**OFFLINE INTERIOR
ELEVATIONS**

AMERICAN EAGLE OUTFITTERS
C. C. Paseo Altozano
Morelia, Michoacan

Space # PB-07 08

ULTIMA ACTUALIZACION DE PROYECTO CON MEDIDAS AS BUILT POR AE-CONSTRUCCION + AJUSTES INDICADOS POR AE (22-FEBRERO-2023)
 *CAMBIO DE LETRERO DE MADERA POR ACRILICO TRANSPARENTE, INDICACION POR AE (03-MARZO-2023).
 ULTIMA ACTUALIZACION DE PROYECTO POR INDICACION AE (27-MARZO-2023) // ULTIMA ACTUALIZACION DE PROYECTO CONFORME A INFORMACION AS BUILT (05-ABRIL-2023)

FIXTURE PLAN
SCALE: 1/4" = 1'-0" (1:50)

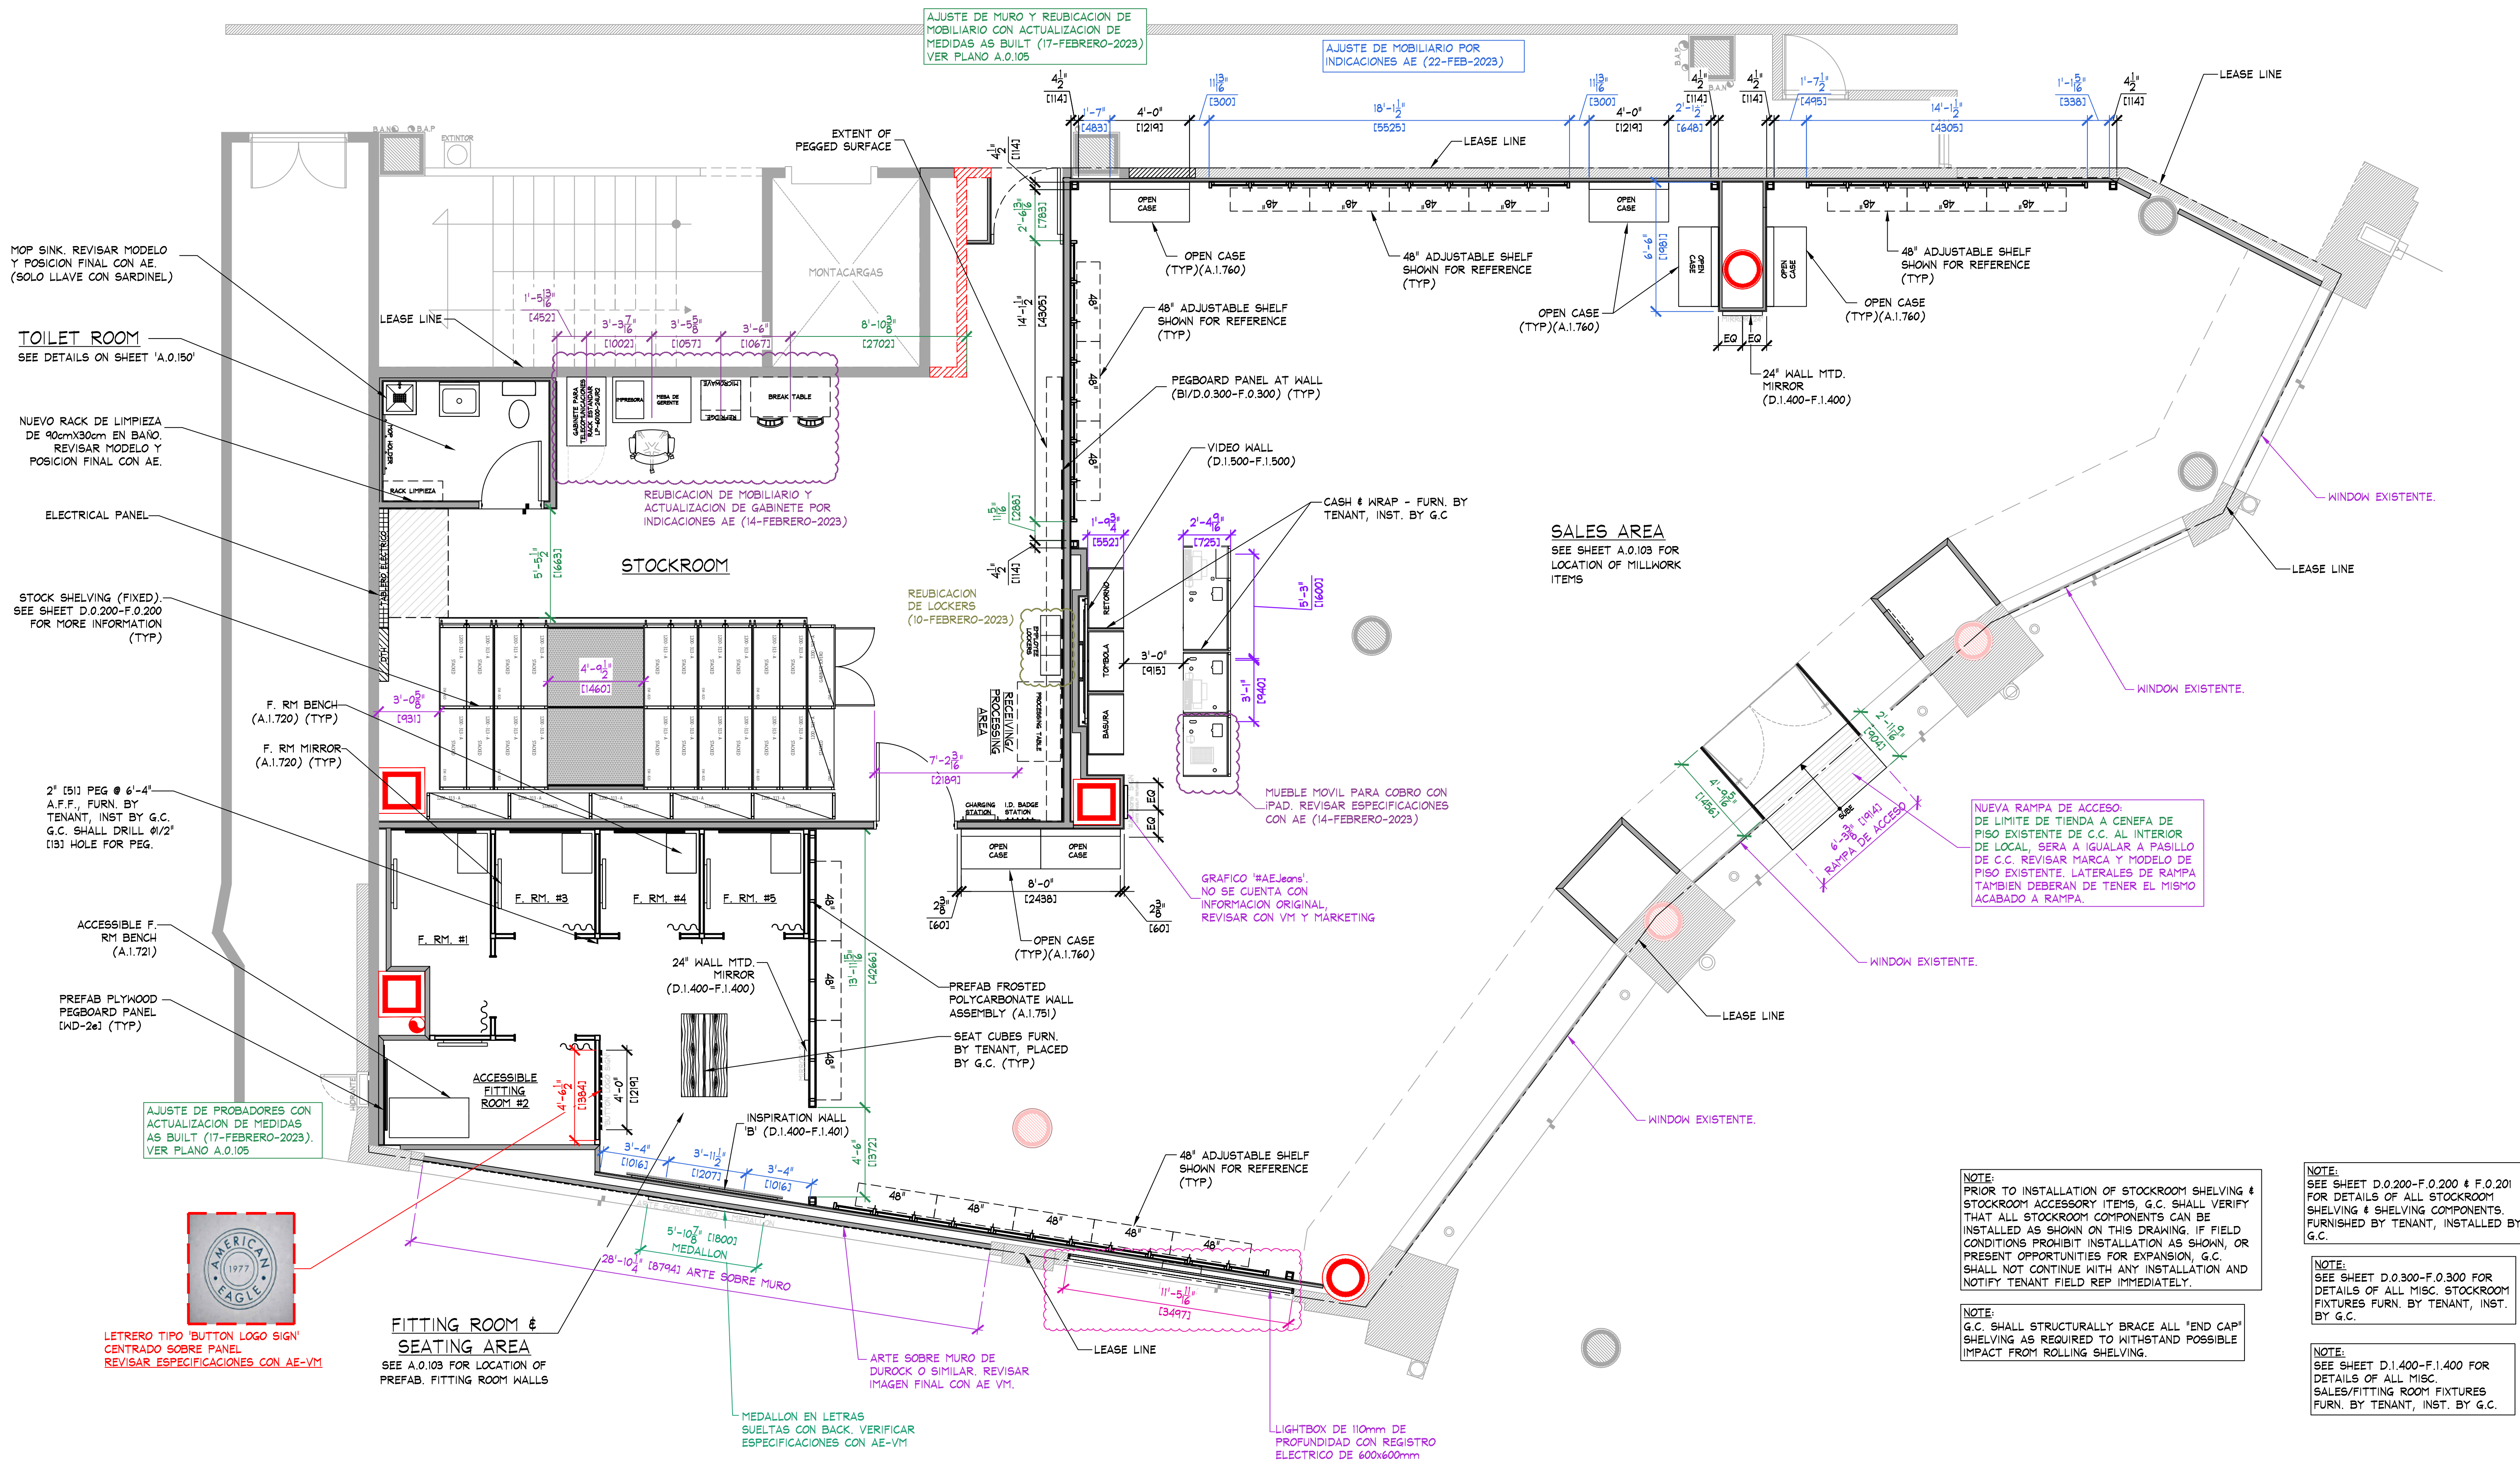
ACTUALIZACION DE TABLA POR
AJUSTE DE LAYOUT (22-FEB-2023)

DEVICE COORDINATION REFLECTED CEILING PLAN

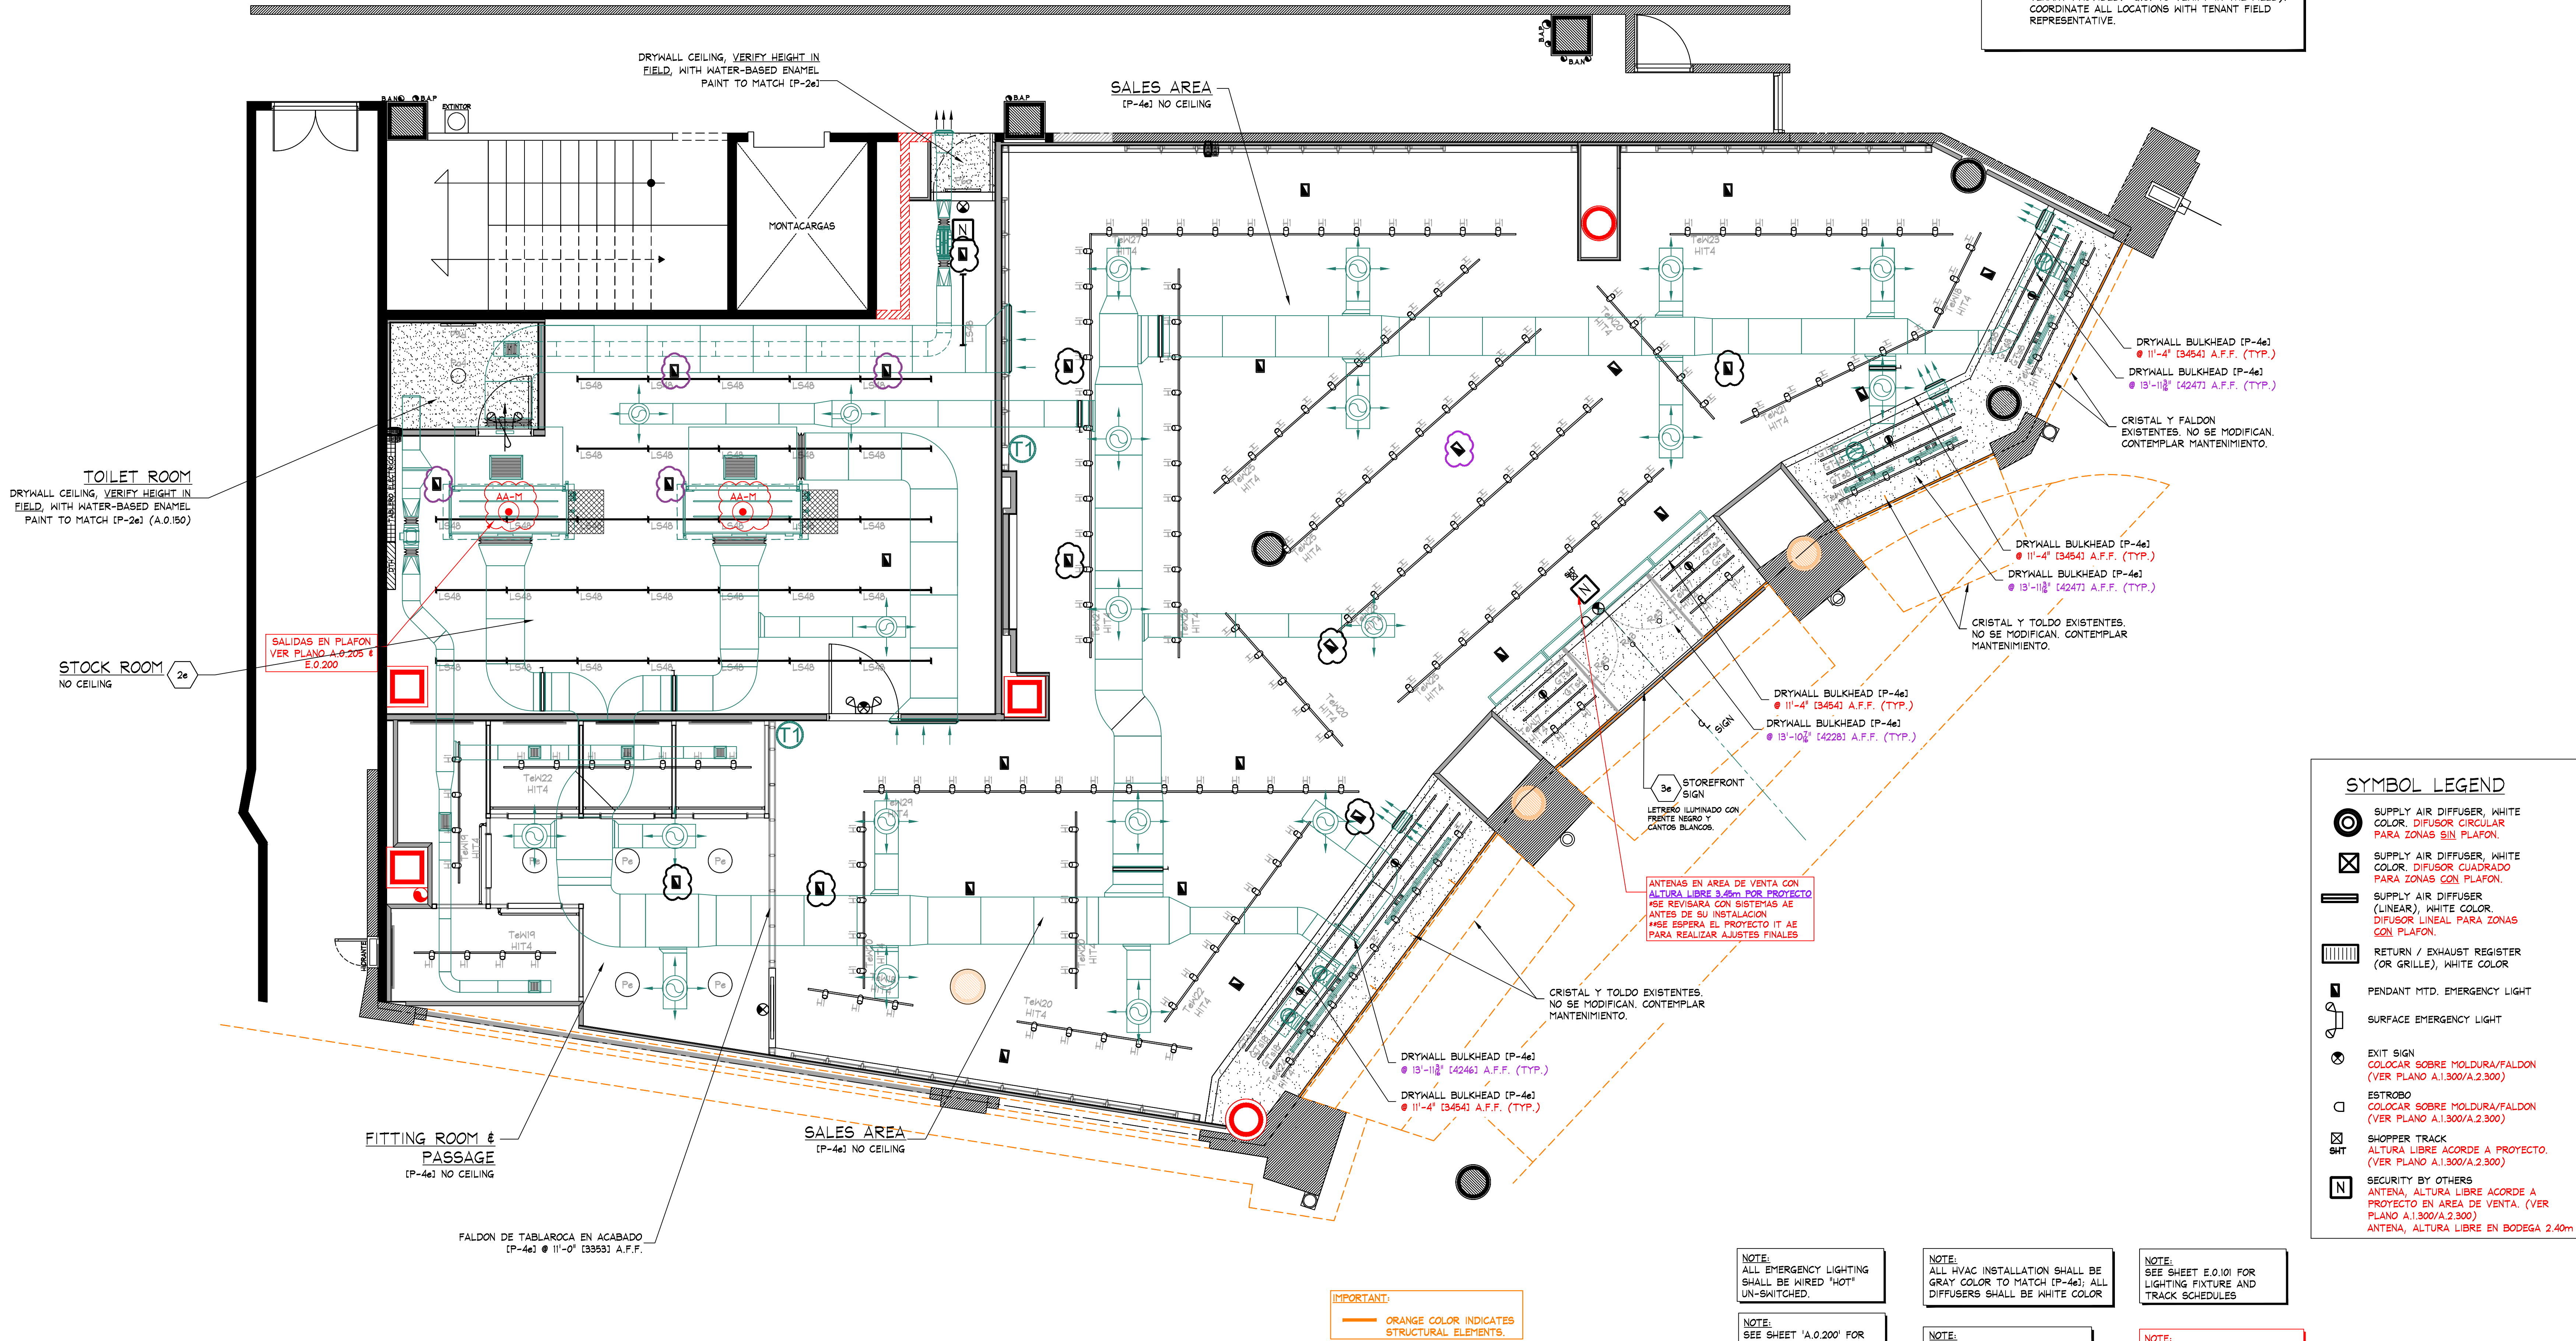
INDICA AJUSTES EN PLAFON POR DUCTERIA DE A.A.
